This amendment responds to the Office Action mailed May 28, 2003, in which claims 1-22 were pending. In the Office Action the Examiner:

Amendment
Attorney Docket No.: 8932-471

Appl. No. 09/879,911
Amdt. dated Sept. 29, 2003
Reply to Office Action of May 28, 2003
Replacement Sheet 5 of 9

FIG. 8a

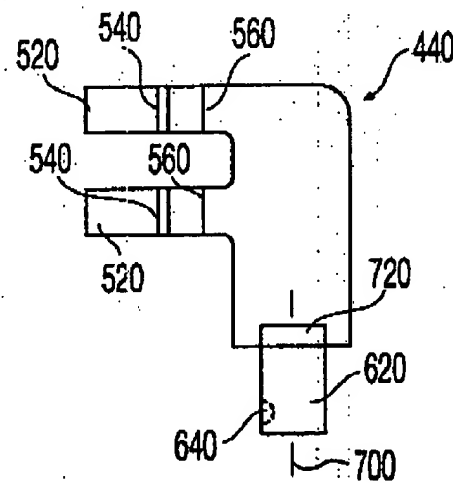
Replacement drawing sheet 5 of 9 is included in Appendix A. In response to the Examiner's objections to the drawings, applicants have submitted replacement drawing sheet 5 of 9 including the new FIG. 8a. An annotated drawing sheet has also been provided for the Examiner's reference. FIG. 8a shows a detachable blades 440 having a mating portion in the form of a post 620 for reception in bore 60 in jaw 14. The post 620 of blades 440 is shown preferably including a depression 640 for a ball detent attachment within bore or socket 60 and a stop plate 720 for limiting the range of pivotal motion of blade 620 about the longitudinal axis 700. Blades 440 are also shown having distracting surfaces 520 which may preferably further include vertebral engagers 540 and transverse engagement walls 560. No new matter is believed to have been added by this replacement drawing sheet.

Applicants draw the Examiner's attention to the specification and claims of the application as filed for support of the replacement drawing sheet. Specifically, FIG. 8a shows all the features associated with detachable blade as provided in claims 7 and 9-16 as originally filed. In addition, blades 440 of FIG. 8a reflect the described detachable alternative to the *preferred* embodiment of blades 244, shown in Fig. 16 and described at page 12, lines 5-12 of the application as originally filed. The Examiner is respectfully requested to approve the drawing changes. Amendments to the specification are shown above and described below to reflect the changes in replacement drawing sheet 5 of 9.

FIG. 8 CORRECTION OF REFERENCE NUMERAL

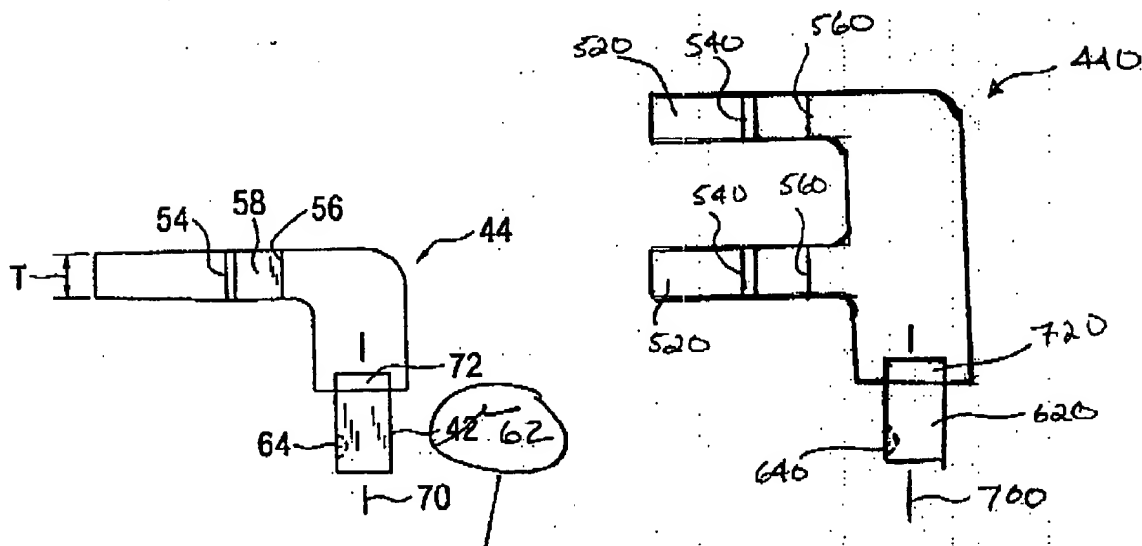
FIG. 8a (ADDED)
